# SERVICE BULLETIN

No. 573

Subject: Wing Fuel Tank Cap Modification

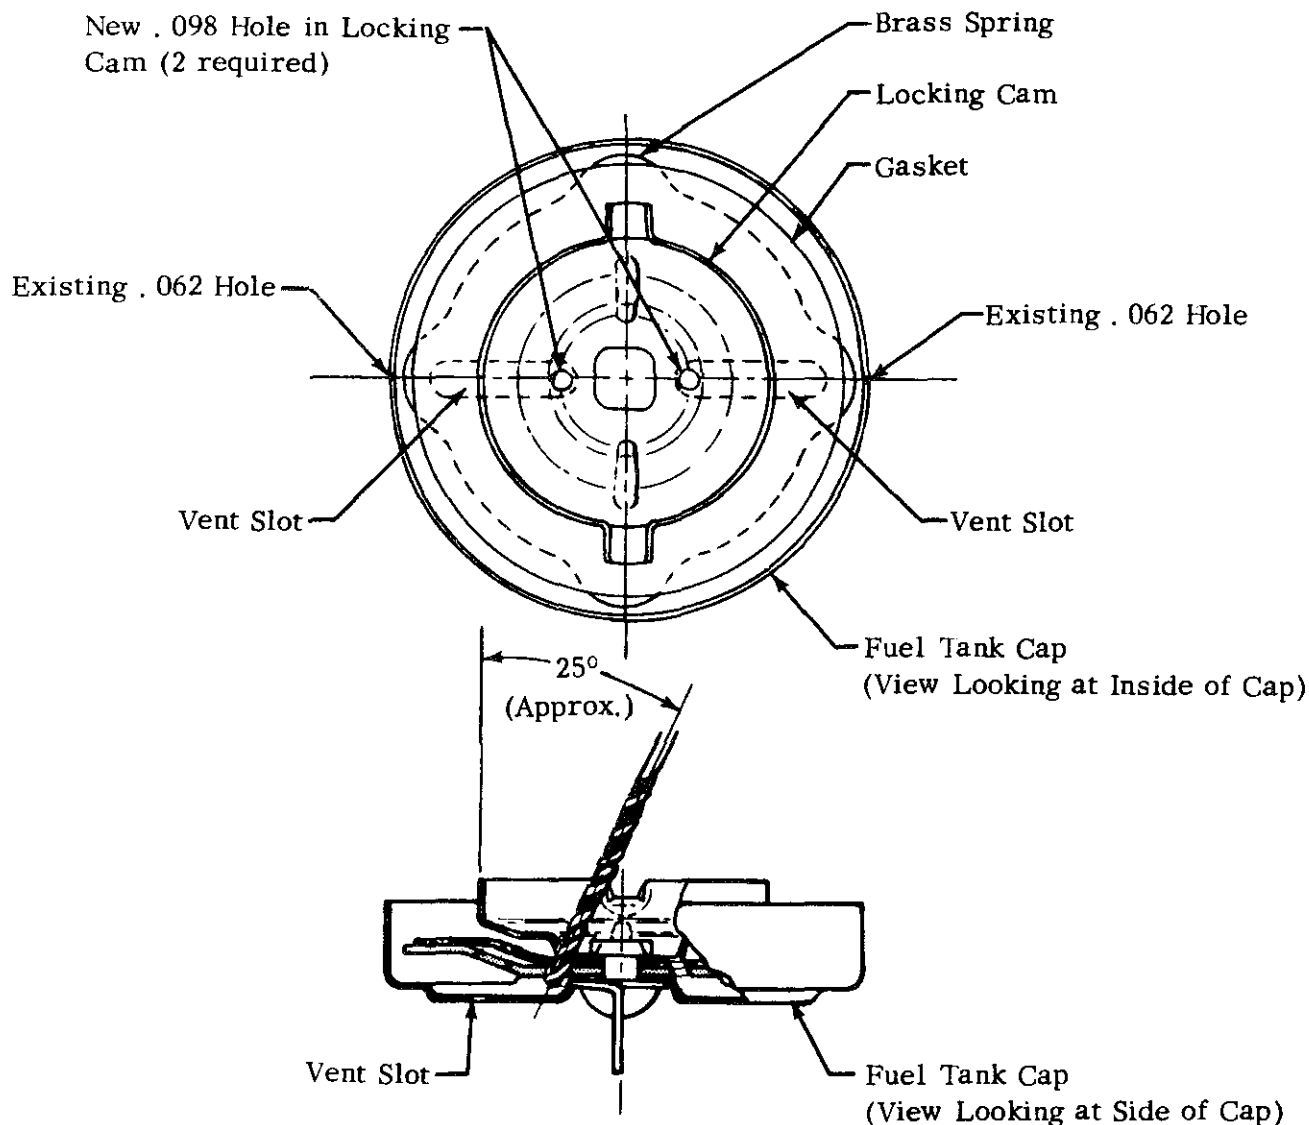
A recent fuel tank collapse was attributed to inadequate venting, caused by obstruction of the cap vent holes (installed per above referenced Service Bulletin). Accumulation of foreign material (corrosion, dirt, ice, etc.) inside the cap "sealed off" the cap internal vent slots.

This service release provides instructions to drill two additional vent holes in the cap assembly to insure adequate venting -- in the event that the present vent slots (located in the cap locking cam plate) are obstructed and recommends cleaning and inspecting present vent slots.

1. Remove fuel tank caps from wings and rework caps as follows:
  - a. Locate and mark center of two .098 holes on locking cam of cap as shown. Use existing .062 vent holes to index location of new .098 holes.
  - b. Drill two .098 holes ( $\pm 40$  drill) through locking cam. Angle drill to intersect end of vent slots as shown. CAUTION: Do not allow drill to go through top cover of cap.
  - c. Insert .032 wire in existing .062 holes. End of wire will be seen in new .098 holes if holes were correctly drilled.
  - d. With .032 wire in .062 holes, slide wire back and forth to loosen any corrosion or dirt that may be in the vent slots. Clean cap thoroughly with compressed air.
2. Reinstall reworked fuel tank caps and make proper Logbook entry of Service Bulletin 573 compliance.
